ONE 90 (PREVIOUSLY WATERS TECHNOLOGY PARK )  
PA 18-013 MODIFICATION SUBMITTAL :  
ISSUE DATE: 10-13-20

PA MODIFICATION - INTENT AND DESCRIPTION:  
To review and approve architectural building related design modifications made during plan check for code compliance and constructibility.

PA MODIFICATION COBALT- BLOCKS REVISIONS SUMMARY

PA MODIFICATION - INDIGO ROWS REVISIONS SUMMARY

GROUND LEVEL PLAN

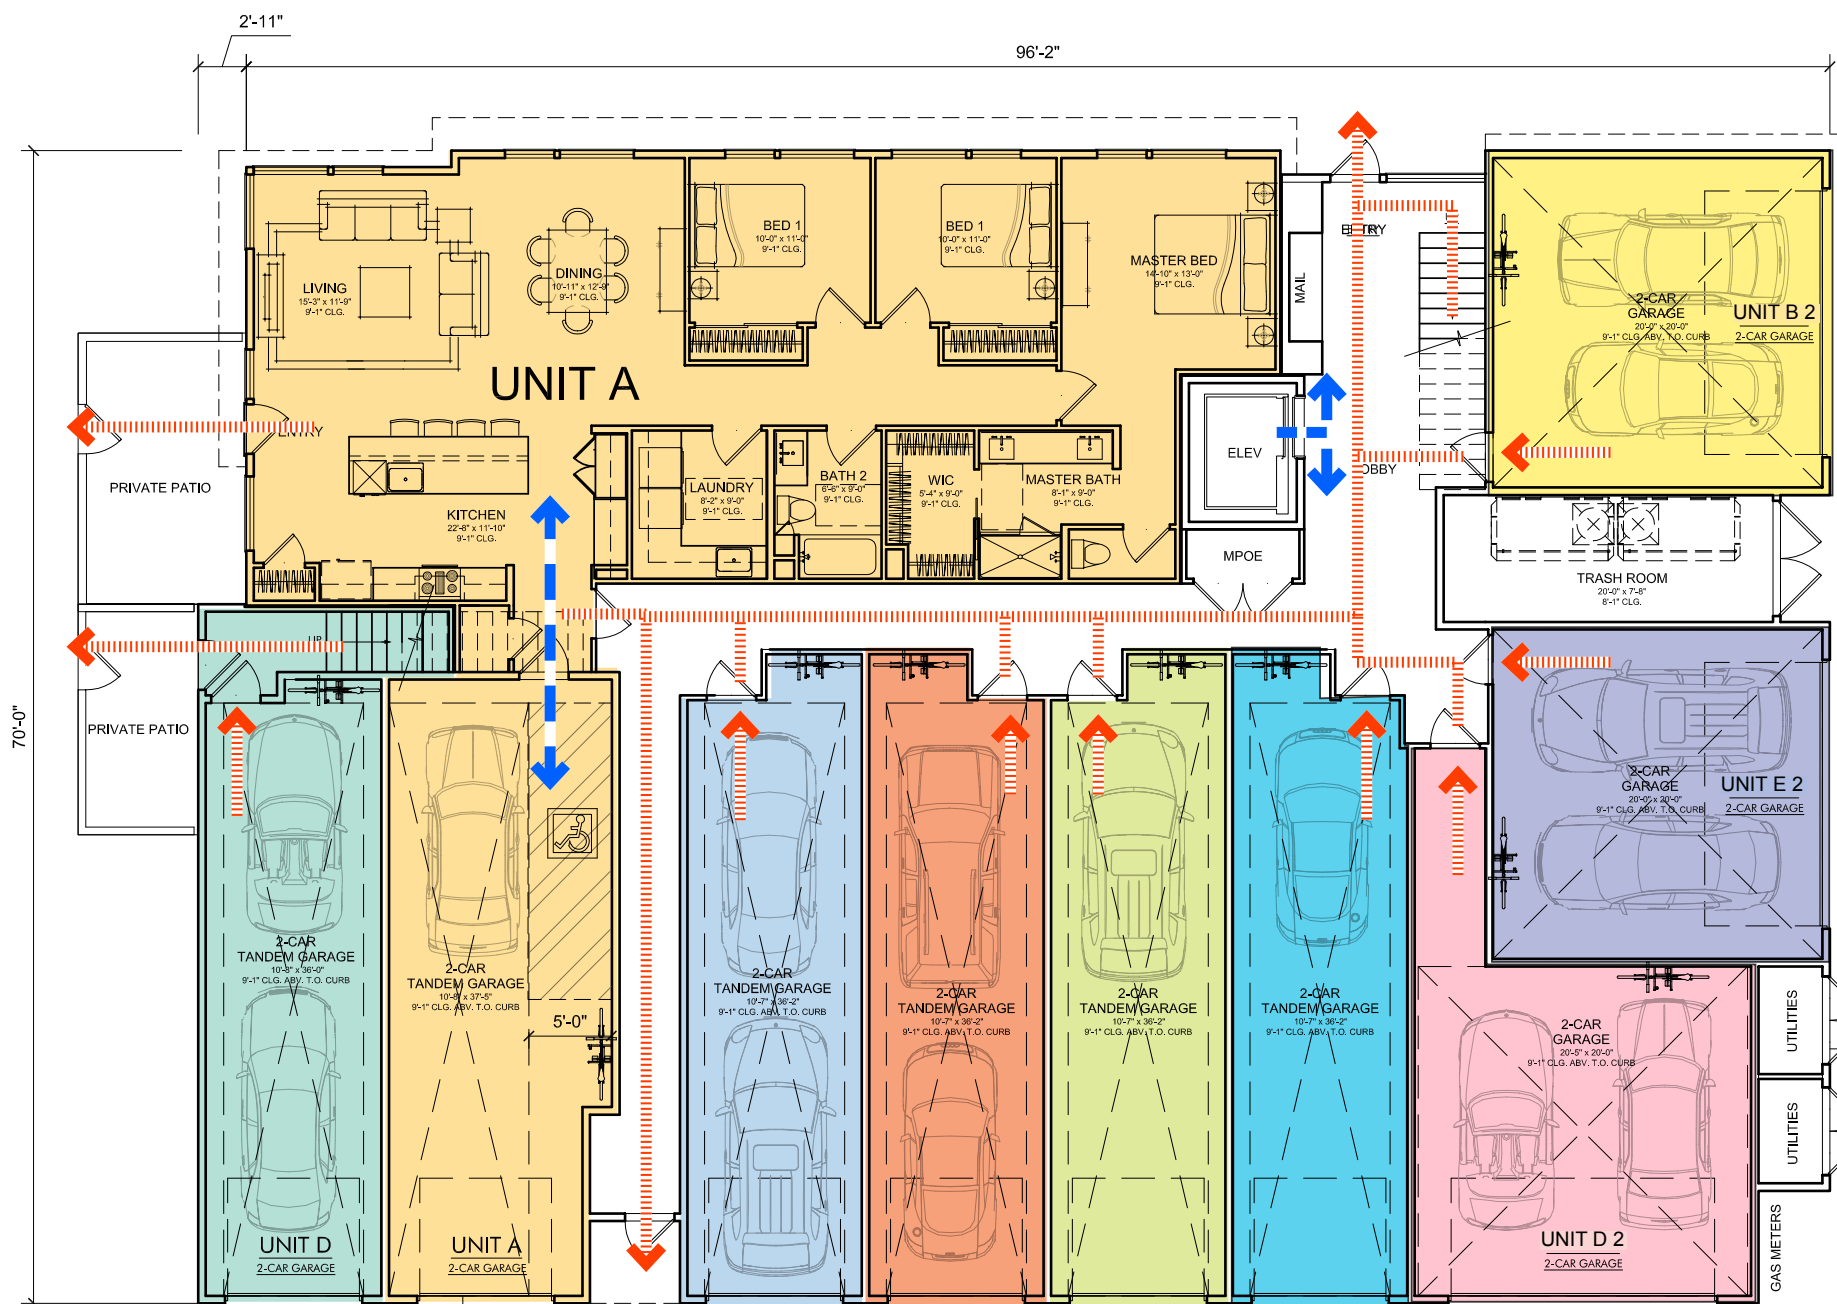
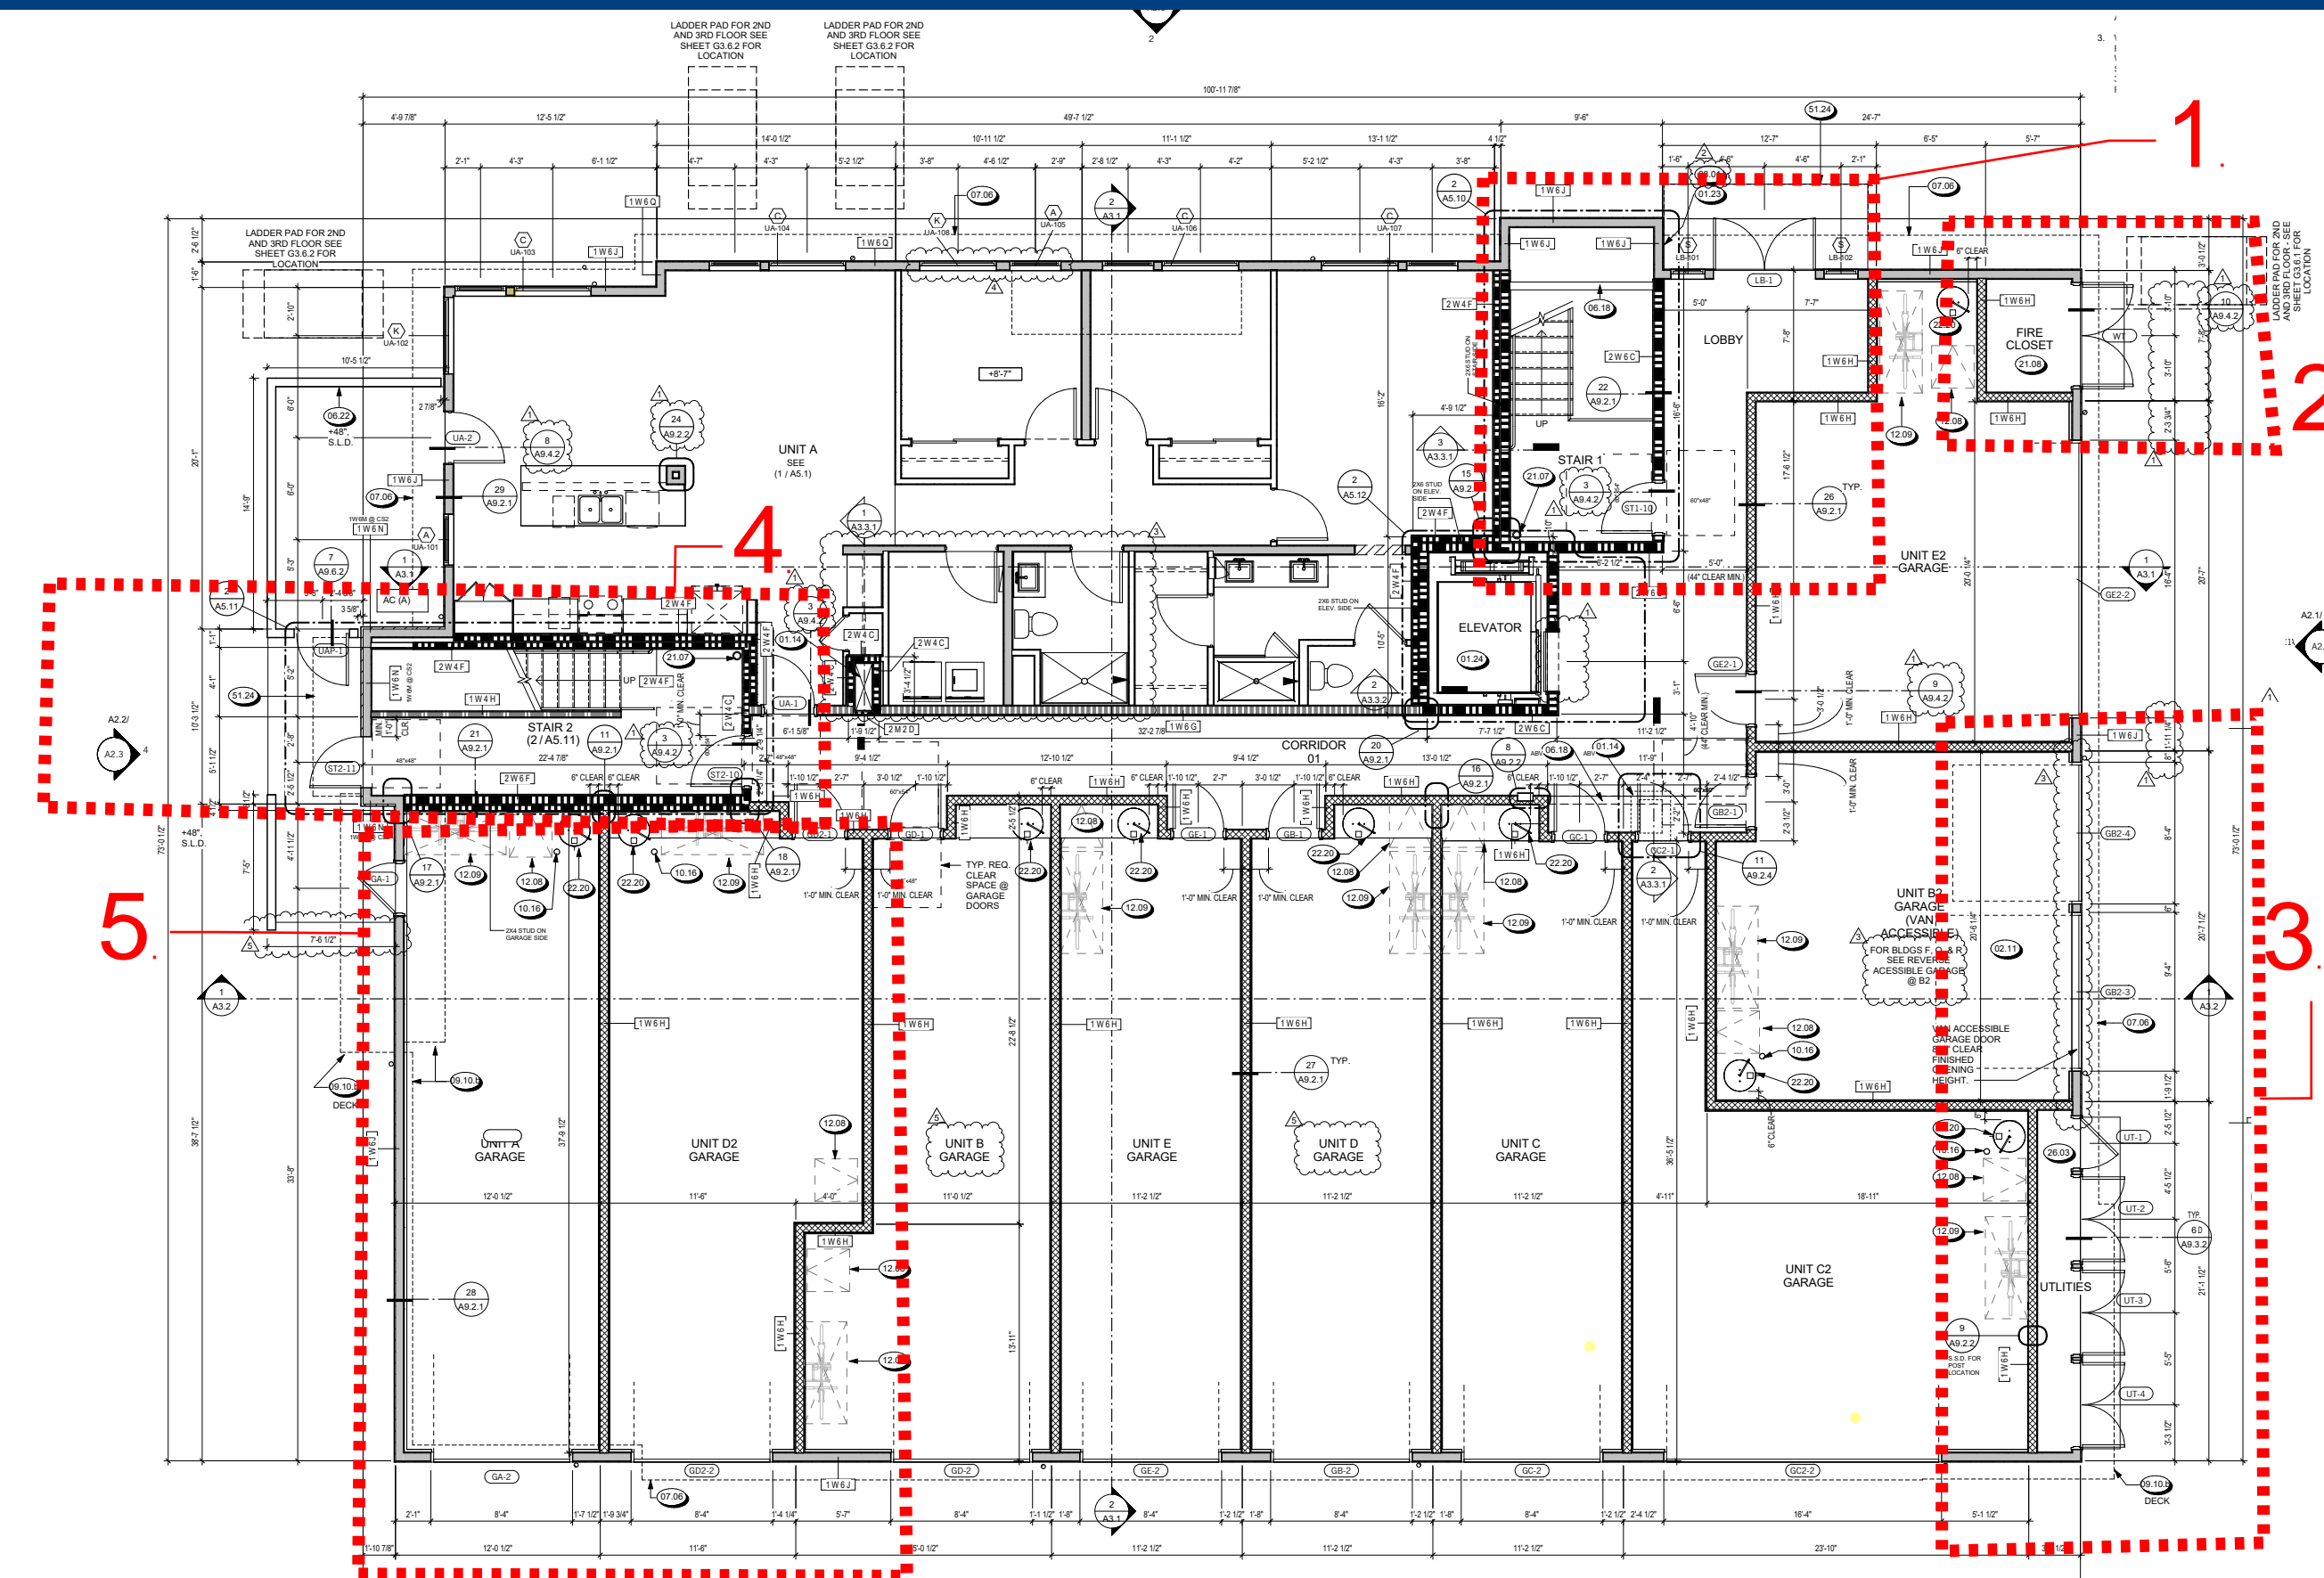
1. First floor common hallway and upper floor hallways were reconfigured to include second exit stair and enclose the lobby exit stair per building code requirements since the building was not code compliant in the previous planning application
2. Fire utility closets were added within current footprint which were missing in the original planning application
3. Electrical utility closets were extended within current footprint.
4. Added second enclosed exit stair as required by building code. This required minor change to the building footprint and exterior wall elevation.
5. Removed non compliant exit hallway. Garages were reconfigured to accommodate van accessible parking in each building per plan check requirements.
